**SAFETY EVALUATION BY  
THE OFFICE OF NUCLEAR REACTOR REGULATION**

**LICENSING TOPICAL REPORT NEDC-33006P**

**"GENERAL ELECTRIC BOILING WATER REACTOR  
MAXIMUM EXTENDED LOAD LINE LIMIT ANALYSIS PLUS"**

**GENERAL ELECTRIC HITACHI NUCLEAR ENERGY AMERICA,  
LLC**

Figure 1-1 MELLLA+ Operating Range Power/Flow Map

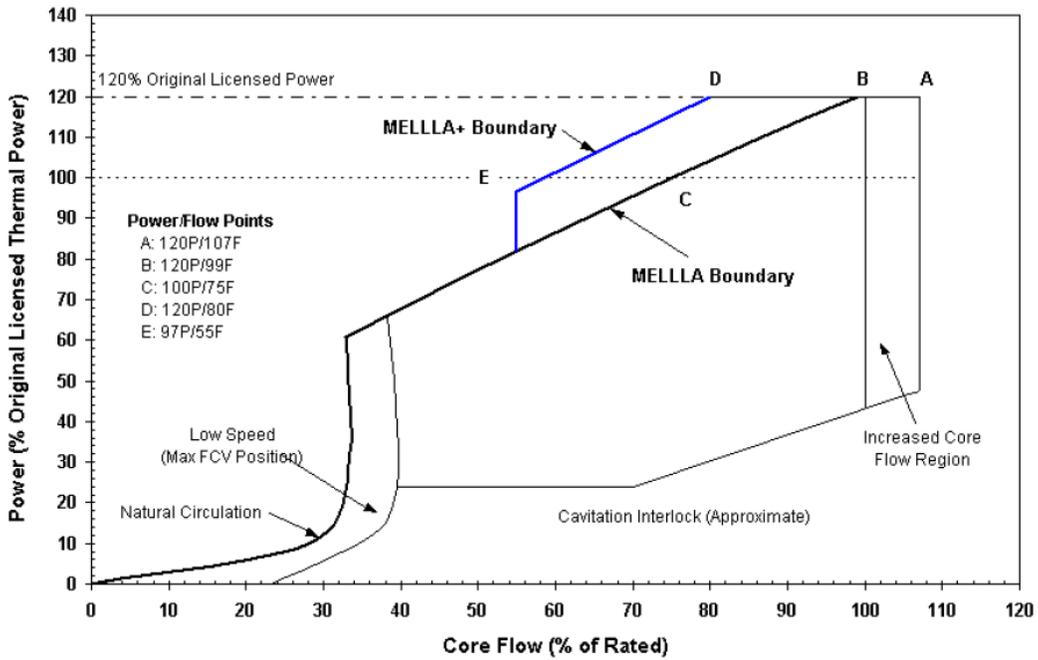
As seen in Figure 1-1, the flow control window in EPU reactors is very small (approximately 1 percent flow). Therefore, reactor operators are forced to either move control rods very often or allow power changes as burn-up takes place. In a typical EPU reactor, the control rods must be repositioned almost on a weekly basis to maintain power at the licensed level.

MELLLA+ attempts to address this flow control issue by increasing the operating range to point D of Figure 1-1 (120 percent OLTP, 80 percent flow); thus creating a 20 percent flow-control window. The EPU plants operating in the MELLLA+ range will require significantly lower number of control rod movements than presently licensed EPU plants. This represents a significant improvement on operating flexibility. It also provides safer operation, because reducing the number of control rod manipulations: (a) minimizes the likelihood of fuel failures and (b) reduces the likelihood of accidents initiated by reactor maneuvers required to achieve an operating condition where control rods can be extracted. However, this safety increase must be compared to other factors such as the higher power effect on transients and the fact that more channels are placed closer to limits by the power-profile flattening.

**Figure 2-1 Illustration of the power-flow map, showing that MELLLA+ operation will result in deeper penetration inside the instability region following a two-pump RPT**

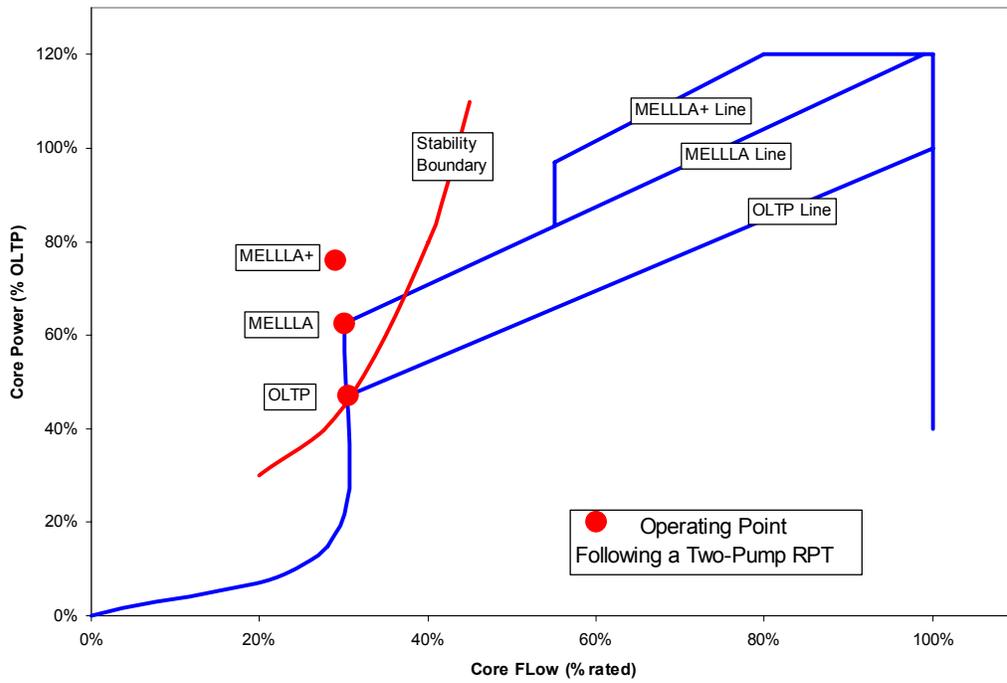
Figure 2-1 of this SE illustrates the reasons for the decrease in stability margin induced by MELLLA+ operation. This figure represents a typical reactor power-to-flow map, with a typical stability boundary line. Operation in the instability region (to the left of or above the stability boundary) can result in unstable power oscillations. As seen in this figure, when operating in the OLTP 100 percent rod line (e.g., at 100 percent OLTP, 100 percent flow), the reactor may or may not become unstable following a 2RPT. When operating on the MELLLA rod line (e.g., 120 percent OLTP, 99 percent CF), the reactor enters the instability region following a 2RPT; thus, the possibility of instability is high. When operating on the MELLLA+ line (e.g., 120 percent OLTP, 80 percent CF), the final operating point following a 2RPT is so far into the instability region that unstable power oscillations are essentially guaranteed.

Figure 2-4 Illustration of DSS/CD Defense in Depth Algorithms

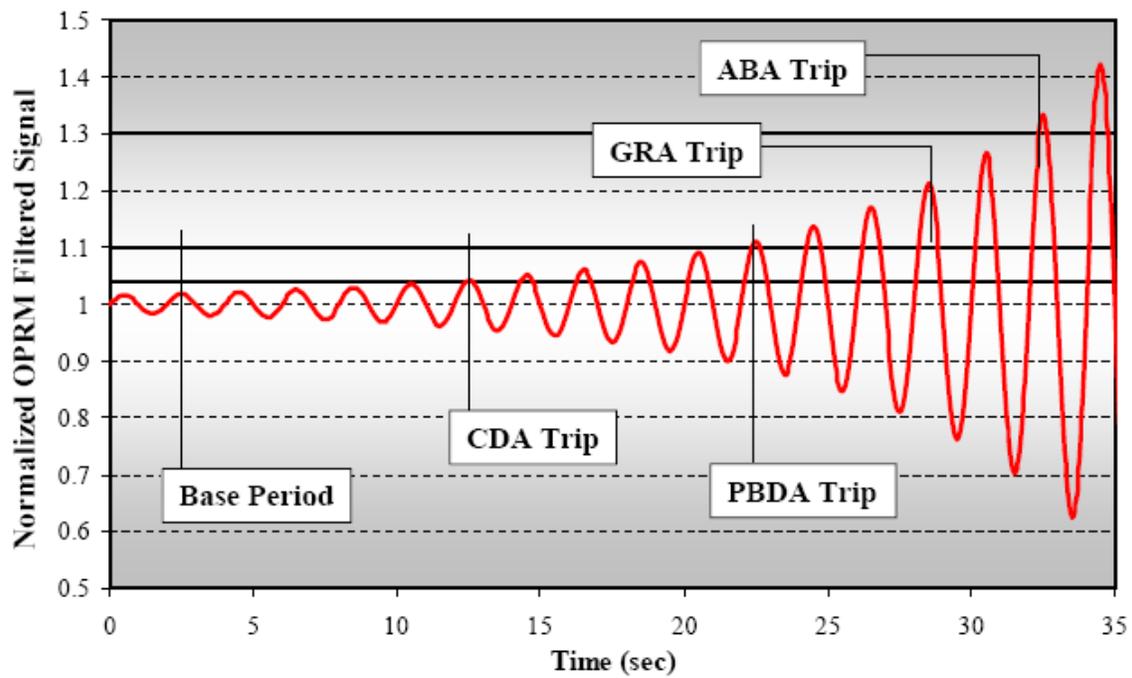
Figure 2-4 of this SE illustrates the operation of the main DSS-CD algorithm (CDA) and the defense-in-depth algorithms (PBDA, GRA, and ABA). The defense-in-depth algorithm would only be required in case the CDA algorithm failed for an unforeseen reason. They are armed when the oscillation amplitude reaches either 10 percent (PBDA and GRA) or 30 percent (ABA).

**Figure 9-1 Illustration of reactor power during ATWS events from MELLLA+ and OLTP initial conditions. The final power is significantly larger under MELLLA+**

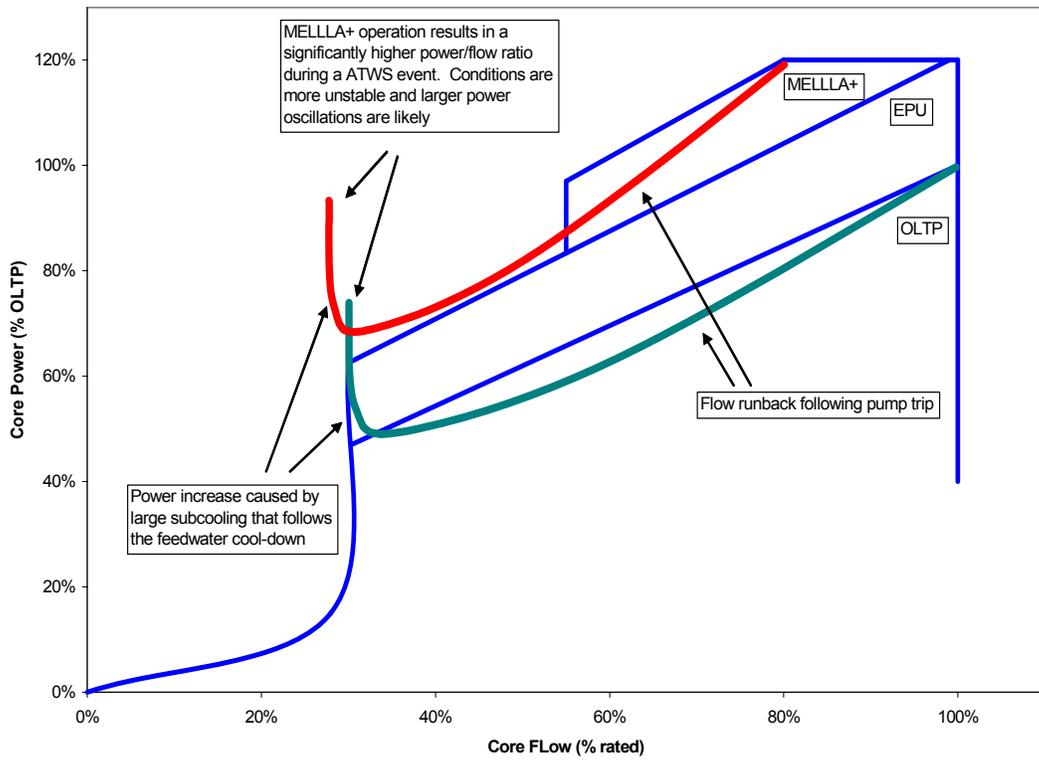
The NRC staff review indicates that, in principle, MELLLA+ operation affects ATWS-Stability. Operation in the MELLLA+ corner (120 percent OLTP, 80 percent CF) results in the reactor settling at significantly higher power, following a RPT, than the event initiated at rated OLTP condition. This higher power makes the final power even larger after the feedwater cool-down period. Thus, at least in principle, the unstable power oscillations are enhanced under MELLLA+, and their consequences should be more severe. This effect is illustrated in Figure 9-1.

**Figure 9-8 Reactor power calculated by TRACE for isolation ATWS.**

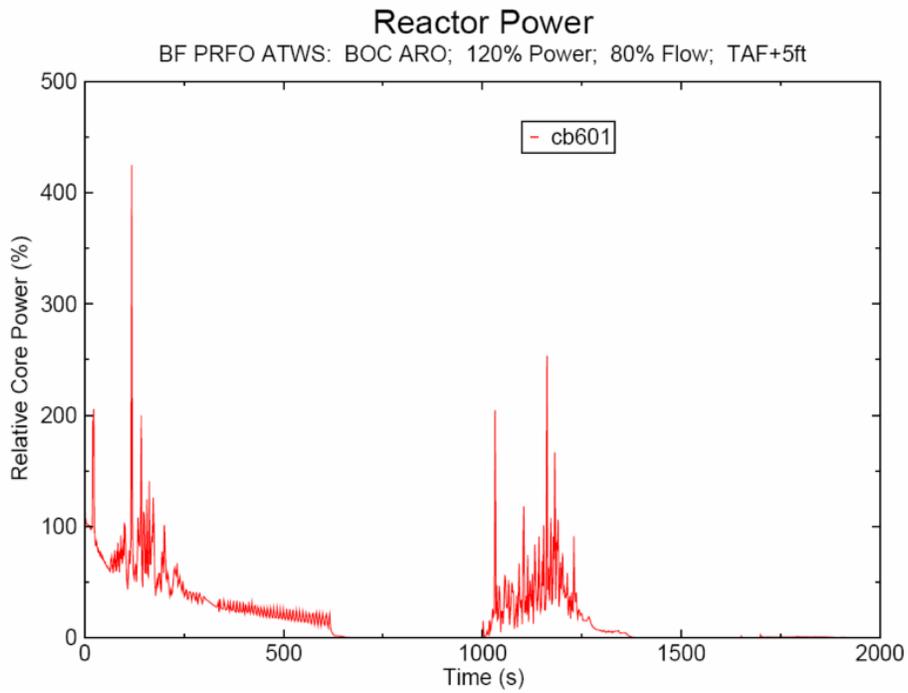
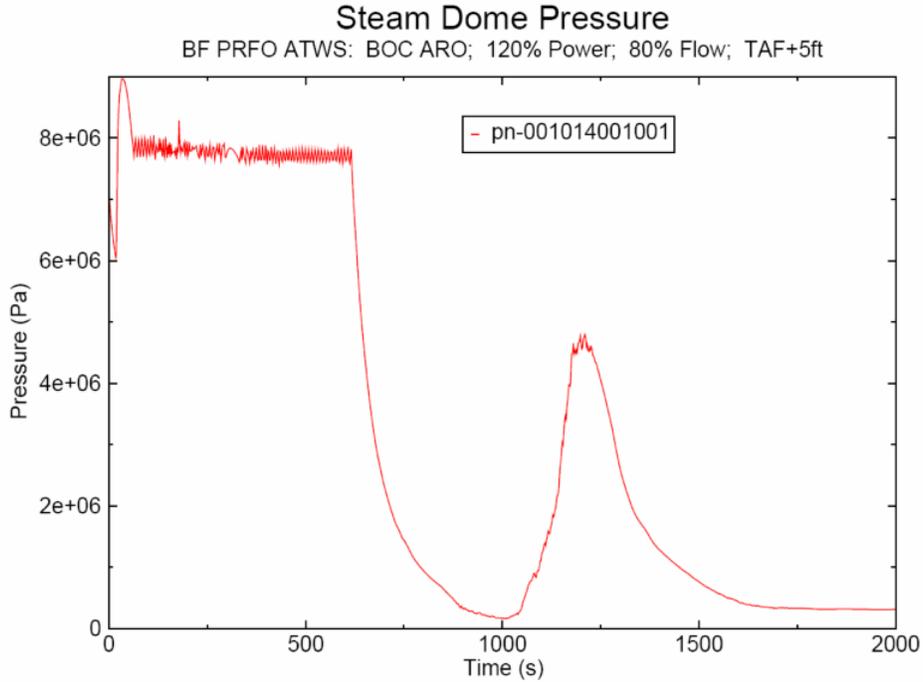
reactor shutdown. During this period, the power level oscillates wildly, and it reaches spikes as high as 200 percent OLTP, with an average of 50 percent to 70 percent. See Figure 9-8 and Figure 9-9 of this SE. The HCTL and emergency de-pressurization start at approximately 600 seconds. Following the emergency de-pressurization, the reactor becomes critical and the pressure recovers. Following a short closure to maintain pressure above 50 psi at time approximately 1000 seconds, all SRVs are open during the re-pressurization event at time approximately 1100 seconds. The calculated suppression pool temperature indicates that containment limits would have been violated in this transient (see Figure 9-10). The HCTL is reached in ~600 seconds. The final pool temperature for the TRACE calculation is approximately 240°F.
